27 January 2015

EF1630/APT

RE: MAISEMORE GARDENS DRAINAGE INVESTIGATIONS

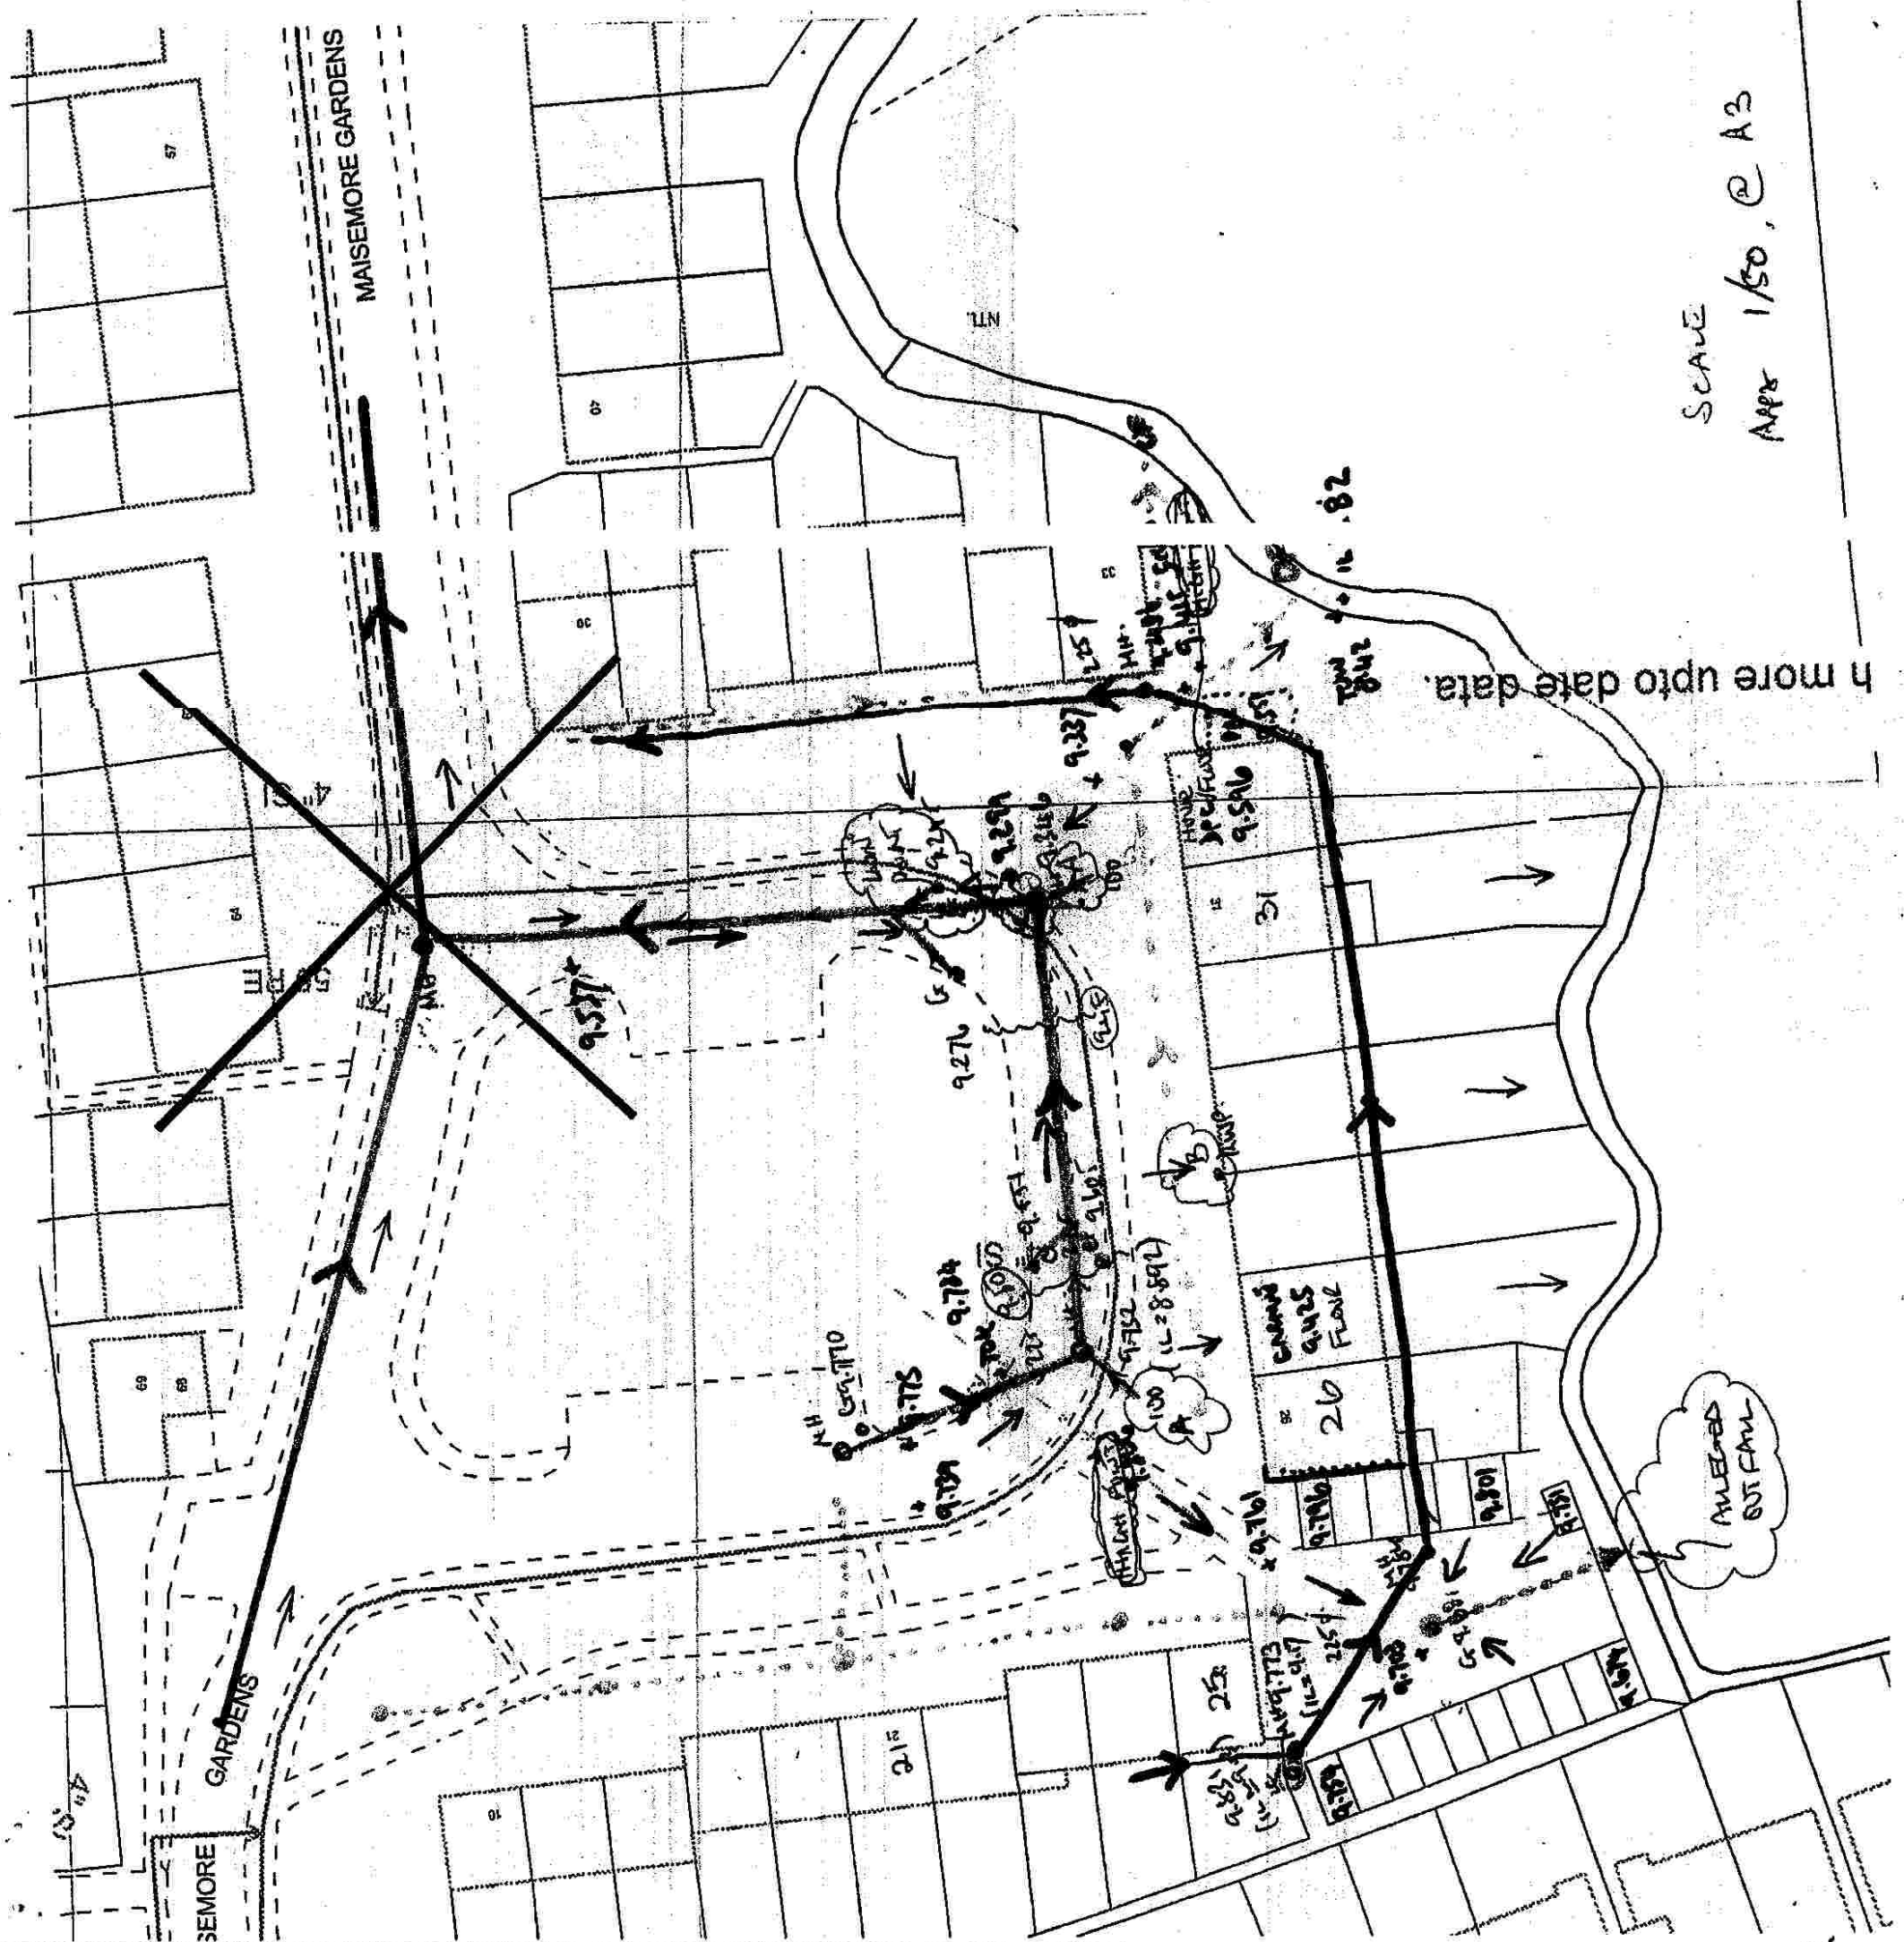
Please refer to the attached Figure 1 which shows the surface levels (to an arbitrary datum) and the key network elements:

1. The garage blocks adjacent No 26 typically have slab levels of the order 9.75-9.80m LD (local datum) with a surfaced central yard area of the order 9.70-9.75m LD. This has a small central yard gully with cover level of some 9.68m LD. There is a slight fall from the garage slabs to the central yard gully but the gradients are slack. The gully was 100% silted up to the surface when inspected. It is not known where this drains to but a resident present in that area at the time of survey stated this discharge direct to the adjacent watercourse. **RECOMMENDATIONS:** Clean out the gully and rod/flush the outlet. Determine where this outfalls and mark on to the estate plan for future reference. Add regular cleaning out of this gully to the estate maintenance schedule.

2. The levels on the access road to the garage forecourt are of the order 9.76-9.81m LD. With the yard gully to the courtyard blocked run-off will pond in the yard until it can run-off the surface into the stream. The surface gradients are however very slack and if surface discharge cannot be achieved to the stream then ponding is likely to reach garage floor levels just before it could run out to the highway. The garage slabs are some 0.2m (8") higher than the finished floor level to No 26. It is therefore important that water is not permitted to pond on the garage courtyard as there is a potential risk of flow towards no 26.

3. The highway channel levels to the front of Nos 26-32 fall from some 9.75m LD to the front of No 26 to a low point of some 9.25m LD to the bend in front of No 32. Whilst there is good longitudinal fall on the carriageway axis it should be noted that this compares to finished floor levels of the block of 9.59m LD internal and 9.42m

LD for the garages. Therefore No 26-29 have property levels below the level of the highway. If the driveways for these properties fall towards the properties which presents a risk. Whilst a linear drain grating could be placed across the garage frontage (as some have), all such gratings would be served by the buried drain at the front and so it is imperative that this drain is functional. RECOMMENDATION: the air brick provision to some of these properties should be reviewed as these lie flush or near flush to the ground surface, which is itself of low elevation and slack gradient. Periscope type air bricks are now available which enable the air inlet on the external wall face to be higher than the underfloor outlet on the rear face. The advice of the product manufacturer's should be sought and considered.

4. From the low point at this bend the carriageway then climbs back up to around 9.5m LD ie if water collects at the low point it could not escape over land along the carriageway until around 0.25m (to") was already ponded, by which time it would exceed garage levels and be close to domestic floor level for No 26-32. Ponded water can however escape over land between Nos 32 and 33 but the ground rises up to about 9.42m LD at the gate to the rear of No 32 before falling away to the stream. Therefore provided this alleyway is not blocked or sandbagged etc ponded water would start to discharge over land at 9.42m LD ie some 0.17m (7") deep at the corner. There are two separate piped systems below ground; the highway system (shown Blue) and the private system (shown green). The manhole cover to the front of No 31/32 appears to have been resited and is not over the chamber which should be beneath it. The private pipe network was proven last year but the outfall is obstructed and it is understood the pipe is susceptible to siltation. Access to the private network is poor. It is imperative that both networks are accessible and maintained. It should also be recognised that these networks have a limited capacity and it would therefore be prudent to consider how to address ponding and overland flow path in the event that capacity is exceeded. It should also be noted that if the highway system comes under surcharge pressure due to the flows coming down the highway system from further above, then the road gully at this bend is one of the places where the internal pressure head may be expressed by manifesting as a static head of water (in this case above ground). RECOMMENDATIONS: reset highway manhole cover over the chamber and investigate connections to it. Install an inspection chamber on the private drain in close proximity to the highway manhole. Remove the paving stone obstructing the private outfall and install a 'flex' valve or similar device. Consider reconstructing the top of the driveway and path round the end of No 32 to slightly lower levels that would decrease the depth of ponding which could occur before escape overland can commence.

5. At the highway manholes to the front of Nos 27 and 32 there are loomm DN connections from the private areas beyond the highway, which do not appear to correlate to any highway asset. It is therefore possible that the private drain is/was linked to the highway drain. There are benefits in the two systems being linked even if at higher elevation than the individual systems. This would enable each system to make some use of each other's outfall once rainfall causes the systems to surcharge. In particular this would facilitate drainage of ponded water from the low road gully across to the private system and out to the stream as discussed in (4) , above. RECOMMEDATION: Local excavation and exposure of the private network pipes in these areas, and/or digging back along the lines of connection into the highway manholes may identify the point to install inspection chamber to maintain/enable this and for future accessibility and maintenance.

A LINK FROM PRIVATE
 DRAIN TO HIGHWAY
 DRAIN?

B PROBABLE LINK
 FROM R.W.P.

C MH L.O. NOT LOCATED
 IN CHAMBER
